Subject: BAR Action November 2014 - 12 Elliewood Avenue

BAR 14-08-01 12 Elliewood Avenue Tax parcel 090088000 Youn Soon Lee, Owner /Stephen Lee, Applicant New front patio and paint building

CITY OF CHARLOTTESVILLE BOARD OF ARCHITECTURAL REVIEW STAFF REPORT November 18, 2014

The photos below show (1) the current condition of the space, and (2) the landscaping that was previously in place:

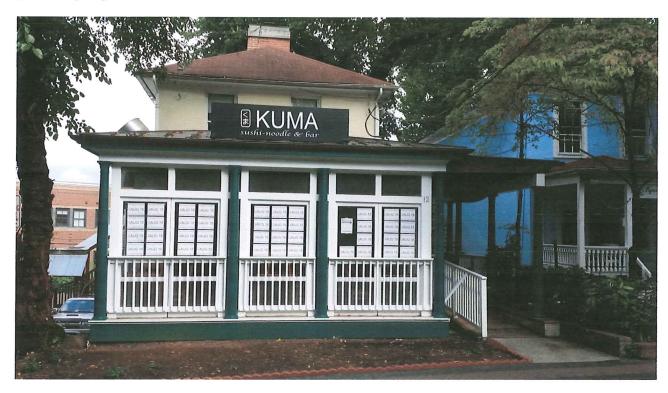
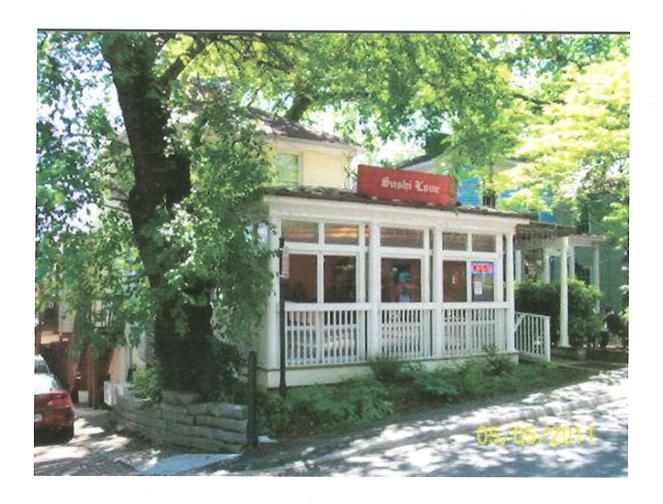
The shrubs that were in front of the property in 2011 have since been removed; it is unknown when this landscaping was taken out. The applicant has also painted the building. The paint job looks professional and with landscaping could significantly enhance the visual experience of the passerby.

As the first picture indicates the building has already been painted. The paint job looks professional and is located in a part of the street that also has unique colors (in example Para Coffee), so it could fall under #5 in the Guidelines for New Construction and Additions. With the addition of a little landscaping the color would not seem so out of place and could significantly enhance the visual experience of the passerby. Colors can always be changed.

The BAR approved (7-1with DeLoach opposed) the painting of the exterior as submitted; with landscape plan to come back for administrative approval in the spring.
